- 2. Kasilof Alaska Subdivision 2022 Replat;
KPB File 2022-119
Johnson Surveying / Renner & Oldham
Location: Old Setnetter Drive
Kalifornsky Area**

ITEM 2 - KASILOF, ALASKA SUBDIVISION 2022 REPLAT

KPB File No.	2022-119
Plat Committee Meeting:	September 12, 2022
Applicant / Owner:	Rosemary M Renner and Darrel Oldham of Kasilof, Alaska
Surveyor:	Jerry Johnson, Johnson Surveying
General Location:	Old Setnetter Drive, Kalifornsky

STAFF REPORT

Kasilof, Alaska Subd. 2022 Replat Preliminary Plat

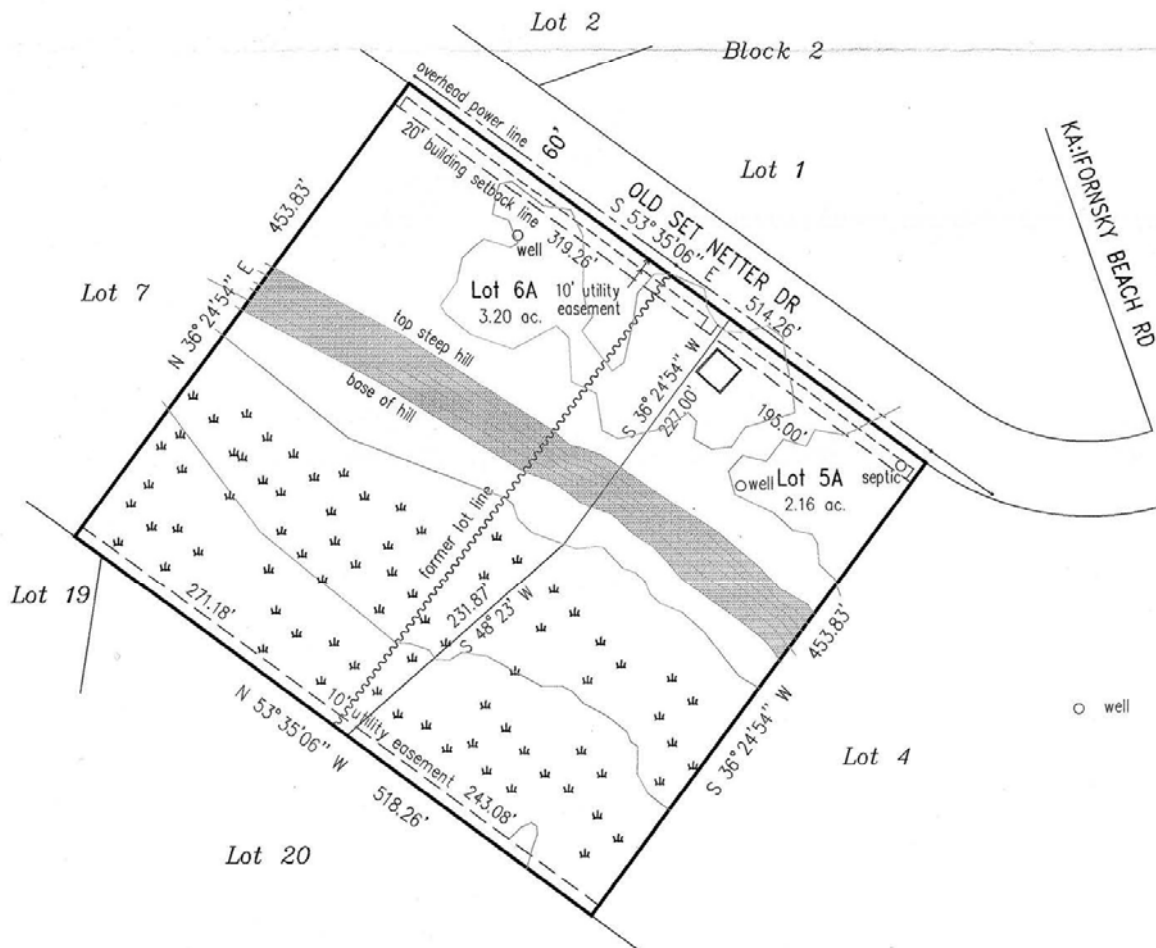
Site Investigation: The replat is flat along the road and then drops steeply in the middle of the lots to wetlands at the back of the lots. **Staff recommends the top and base of the hill remain on the final plat as well as the low wet areas and add a wetland determination plat note.**

There are several buildings on both lots. The plat depicts one of the existing structures to demonstrate it will not be encroaching over the new lot line. Per KPB GIS imagery, a building further east from the depicted structure is closer to the right-of-way. There is not a depiction or plat note on the parent plat indicating a setback or easement was put into place. **Staff recommends the placement of the structure be verified and disclosed to staff, if the building is within the setback and/or utility easement the structure shall be shown on the final with a plat note stating it predates the setback and utility easement.**

Utility Easements Kasilof Alaska Subdivision Amended KN 83-166 granted 10 foot utility easements along the back lot lines that is being carried over to the proposed replat. **Staff recommends the label include the plat information that created the easement.**

Code compliant easements are proposed to be granted by this plat along Old Setnetter Drive. **Staff recommends the depiction be updated for the intended 20 feet within 5 feet of the side lot lines as the depiction is offset.**

Check distances on back lot line compared to parent plat.
Show pins found or set on drawing.
Show basis of bearing on plat.
Show measured and recorded distances and bearings on drawing.
If this drawing was created from non-surveyed data, a note should have been added stating such.
Add surveyors' certificate and seal
Add legend

Staff recommendation: Update the parent name to include "Amended".

Staff recommendation: Block label needed.

Kasilof, Alaska Subd. 2022 Replat Preliminary Plat

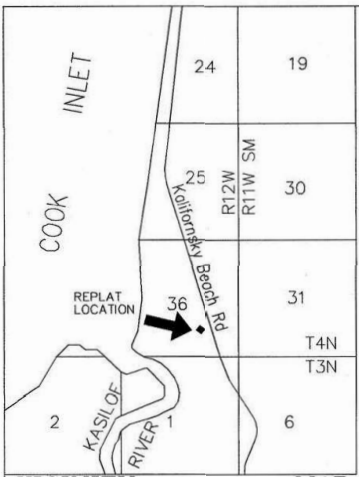
HEA REVIEWED, AND REQUESTS UTILITY EASEMENTS AS NOTED.

HEA	Revise utility easement at the new lot line. Provide a 20-foot-wide electric easement centered on the existing overhead electric line for any portion of the secondary service that crosses Lot 6A and provides electricity to 5A that will not be encompassed by the easement that adjoins Old Setnetter Drive.
ENSTAR	No comment
ACS	
GCI	Approved as shown
